Duke Energy Corporation

SUBJECT: Duke Energy Corporation (DEC)
McGuire Nuclear Station Units 1 and 2
Docket Nos. 50-369/50-370
Proposed Technical Specification (TS) Amendments
TS 3.7.15 - Spent Fuel Assembly Storage
TS 4.3 - Fuel Storage

Attachment 1 provides marked up pages of the existing McGuire TS's showing the proposed changes. Attachment 2 contains the new

Figure 3.7.15-1 (page 1 of 1)
Required 3 out of 4 Loading Pattern for Restricted Region 1A Storage

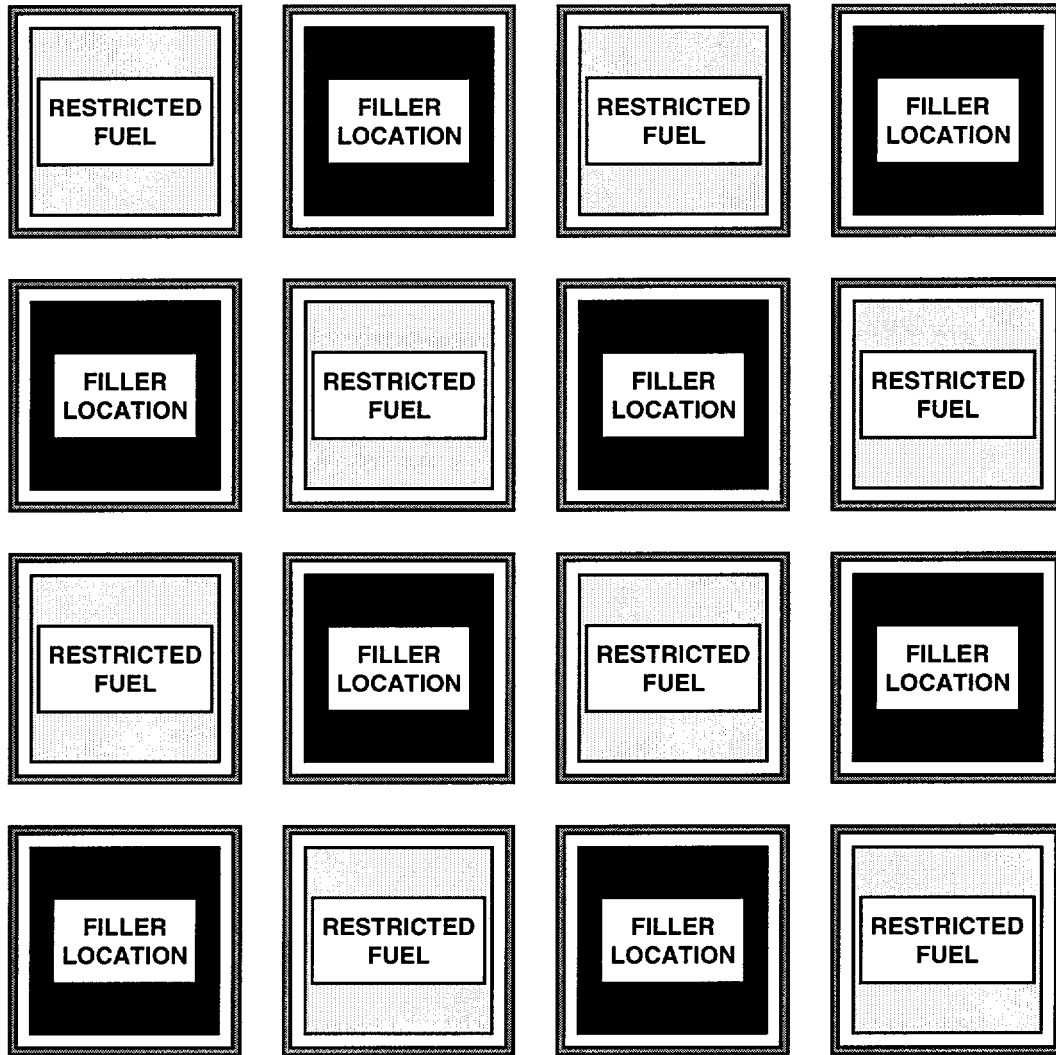
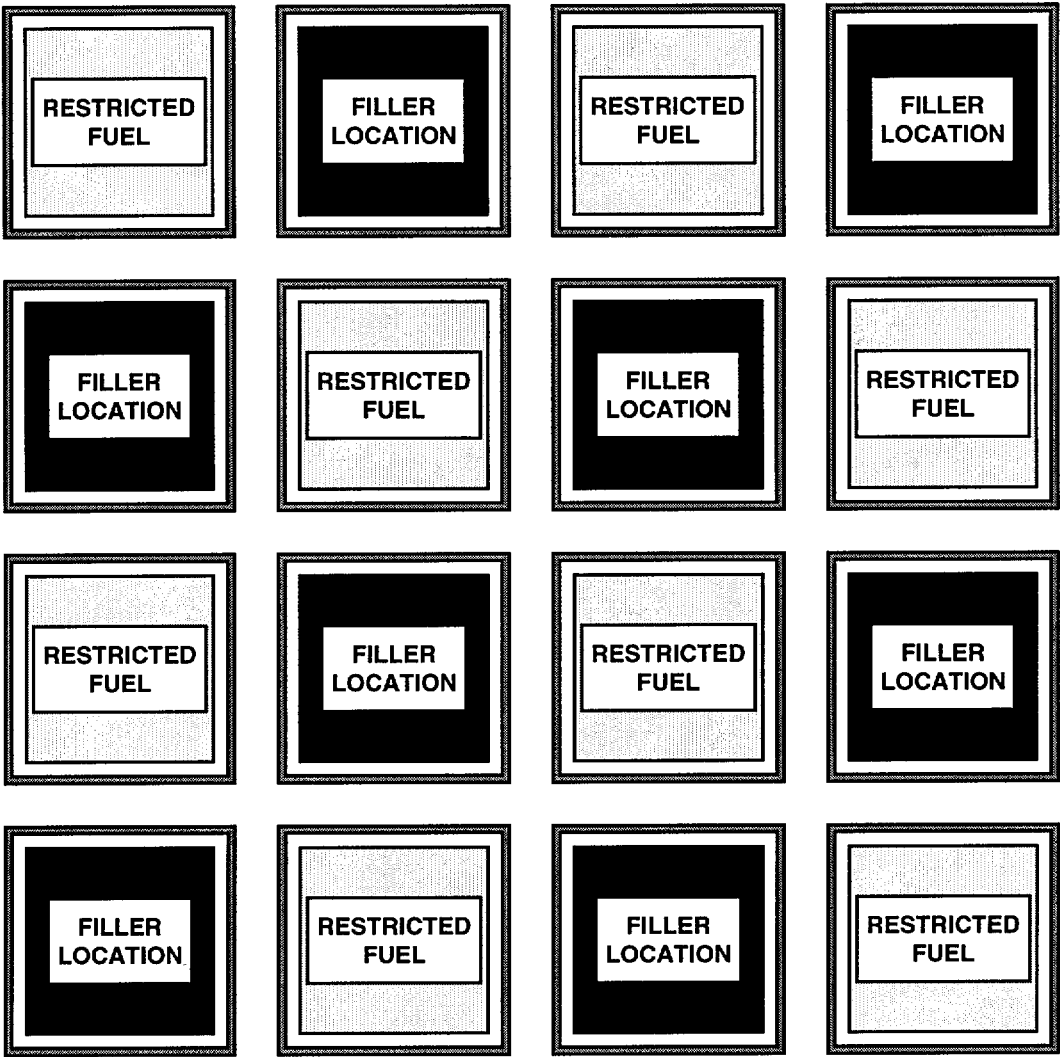
- 3 2. Restricted storage in accordance with Figure 3.7.15-1, of fuel which does not meet the criteria of Table 3.7.15-1 or Table 3.7.15-2.

- 2. Unrestricted storage of fuel meeting the criteria of Table 3.7.15-2; or
 - 3. Restricted storage in accordance with Figure 3.7.15-1, of fuel which does not meet the criteria of Table 3.7.15-1 or Table 3.7.15-2.

Figure 3.7.15-2 (page 1 of 1)
Required 2 out of 4 Loading Pattern for Restricted Region 1B Storage

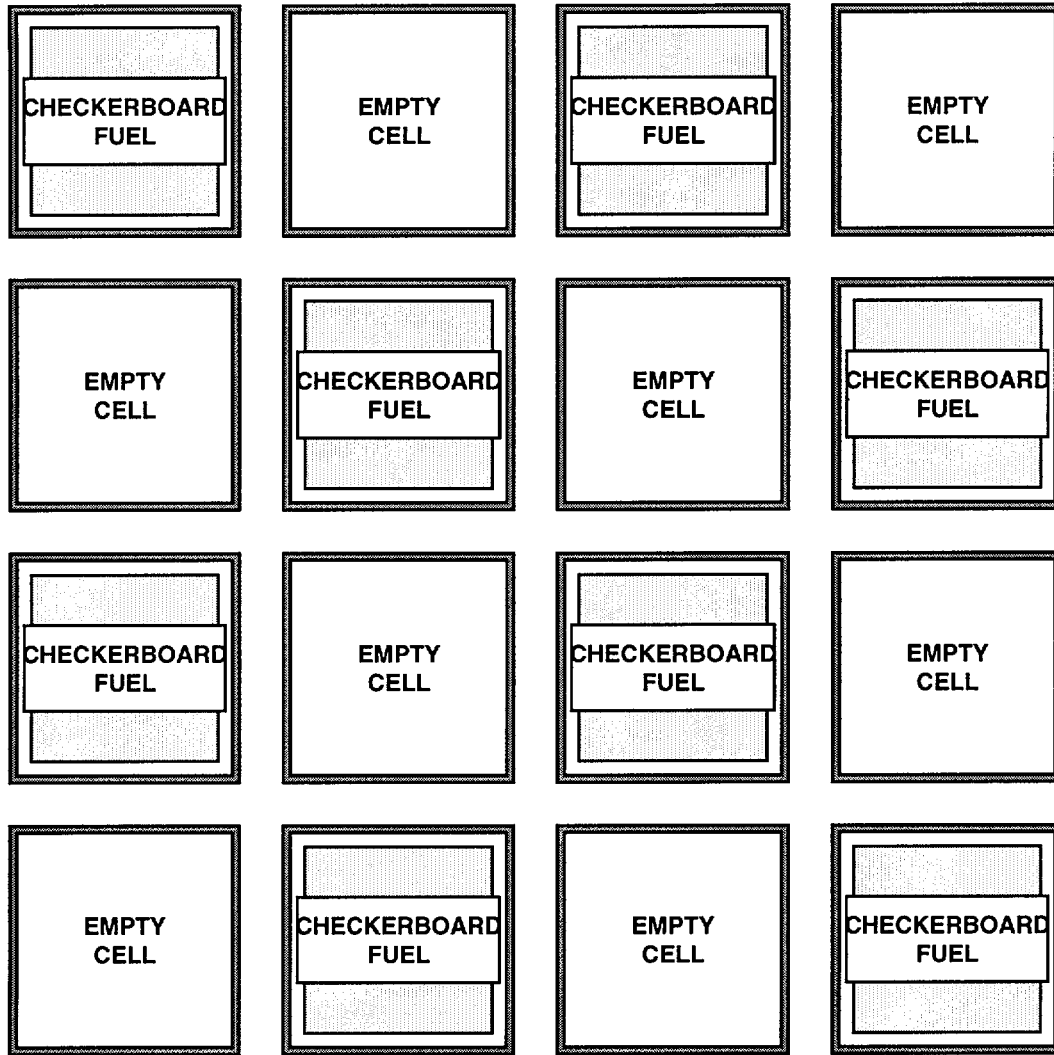
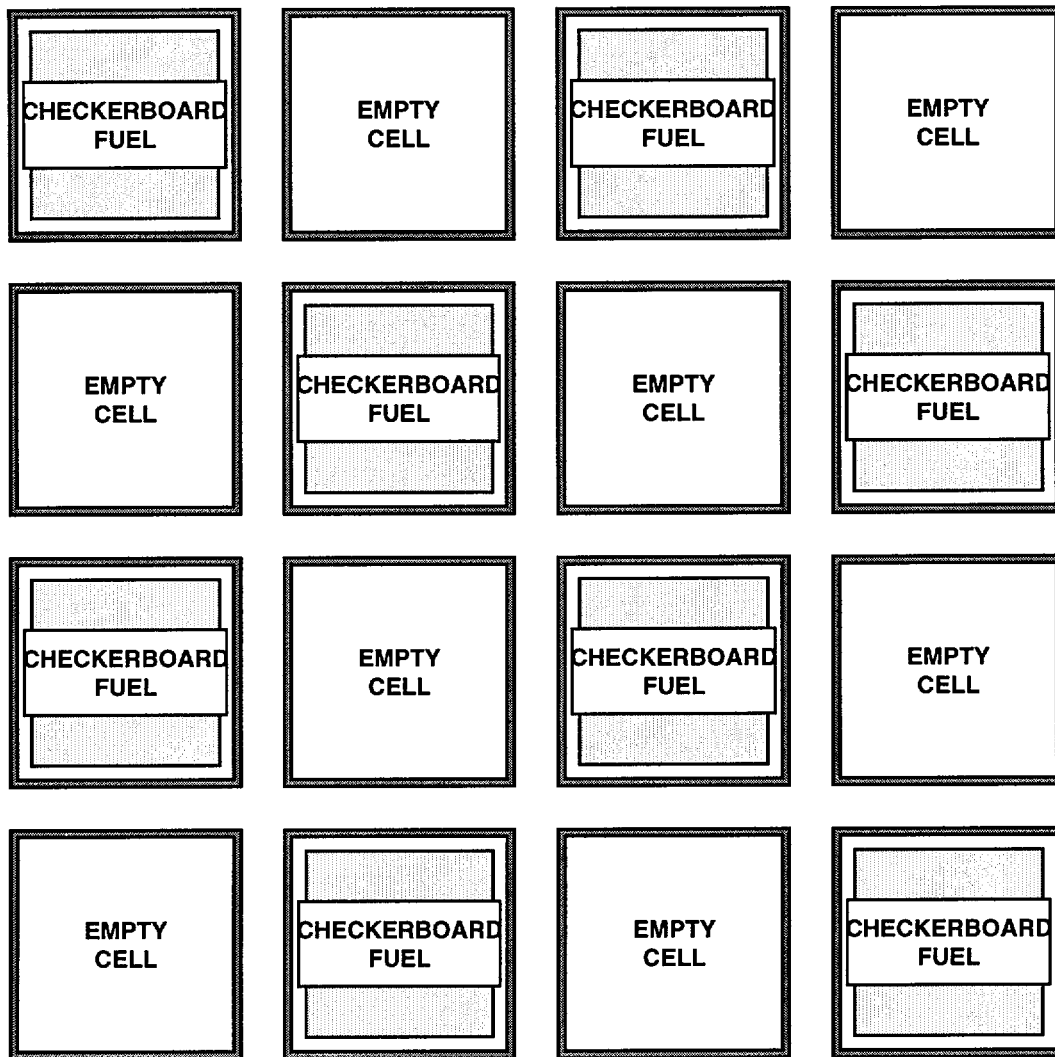
2. Restricted storage in accordance with Figure 3.7.15-2, of fuel which meets the criteria of Table 3.7.15-4 5, or

Restricted Fuel: Fuel which meets the minimum burnup requirements of Table 3.7.15-45 or non-fuel components, or an empty location.

- 2. Restricted storage in accordance with Figure 3.7.15-2, of fuel which meets the criteria of Table 3.7.15-5; or
 - 3. Checkerboard storage in accordance with Figure 3.7.15-3 of fuel which does not meet the criteria of Table 3.7.15-5.

Figure 8
McGuire Region 1A and 1B
Burnup versus Enrichment Limits

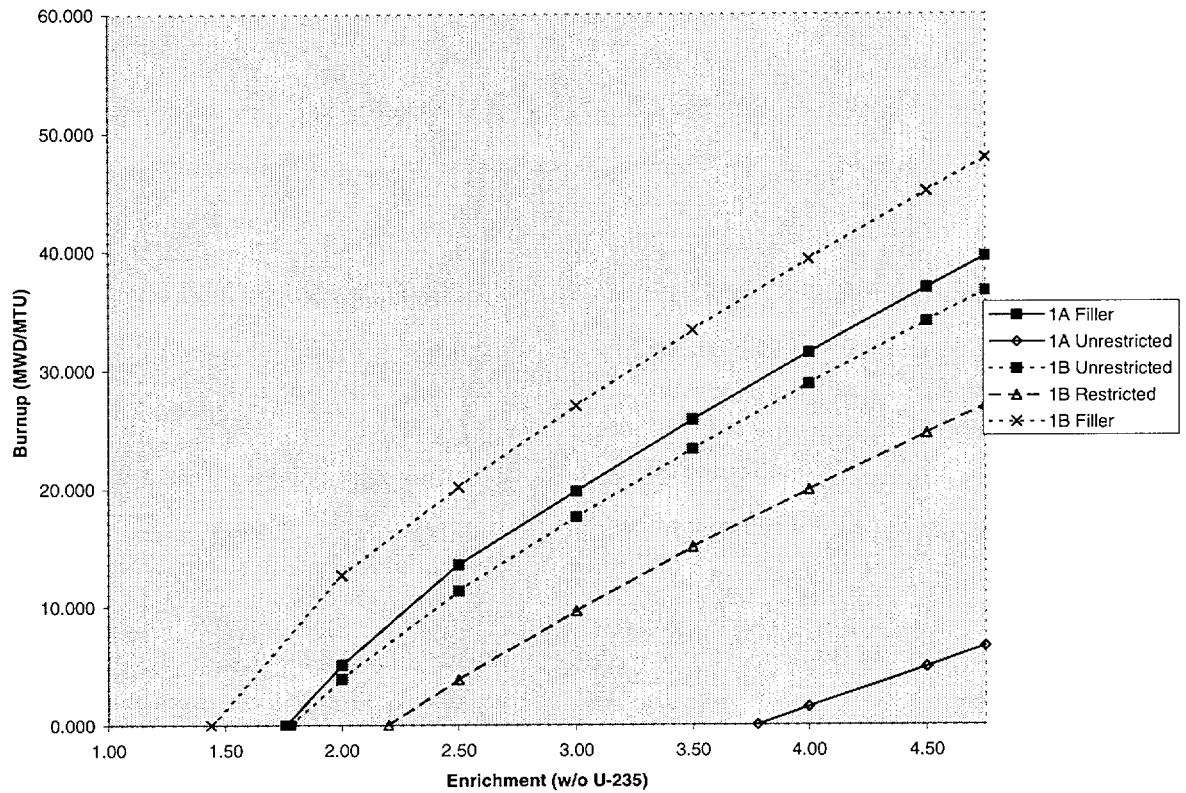
Page 42: Updated Figure 8 to change fresh fuel enrichment limit for Region 1B Filler requirements from 1.45 to 1.44 w/o U-235.
